Anchor/Darling

December 19, 1985

Subject: Illinois Power Company
Clinton Power Station
P.O. C-2513
A/DV S.O. E-6214

The above referenced letter described a problem with missing lock welds on hinge pin setscrews. During an investigation of this problem at the V.C. Summer Nuclear Station it was discovered that on some 150 & 300 class valves lock welds were also missing at the hinge support/hinge support capscrews interface and at the hinge support/bonnet interface.

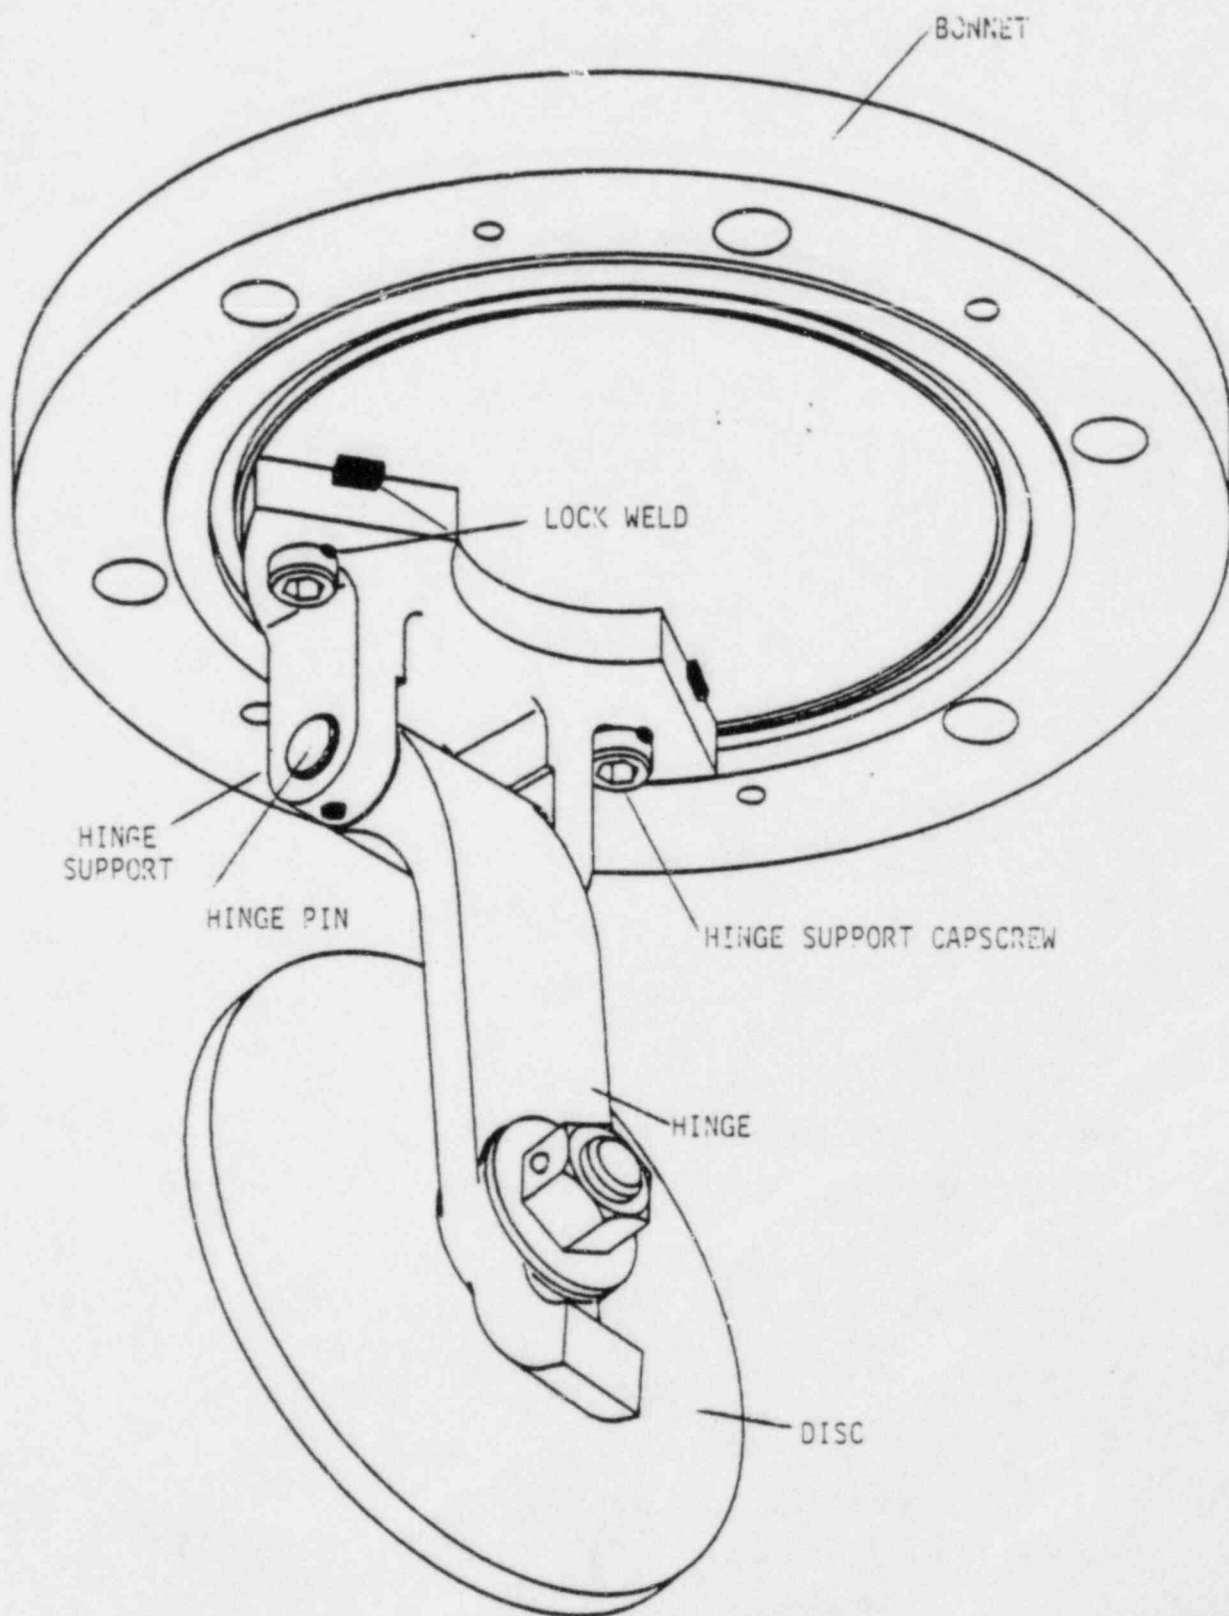
As shown on the attached sketch, the hinge support capscrew is lock welded to prevent it from backing out and allowing the disc and hinge assembly to drop below the seat.

Additionally, in order to maintain the geometry necessary for tight shutoff, the hinge support is lock welded to the bonnet. If this weld is missing, the hinge support could conceivably shift, by an amount equal to the clearance between the hinge support and the hinge support capscrew, thus preventing the valve from seating properly.

Since both these problems could effect valve operability, we recommend that the subject valve(s) be inspected to verify that they have been lock welded.

Some carbon steel valves were originally furnished with alloy steel hinge support capscrews. If these capscrews have not been welded, we recommend they be replaced with carbon steel bolting and welded with a P1 weld procedure.
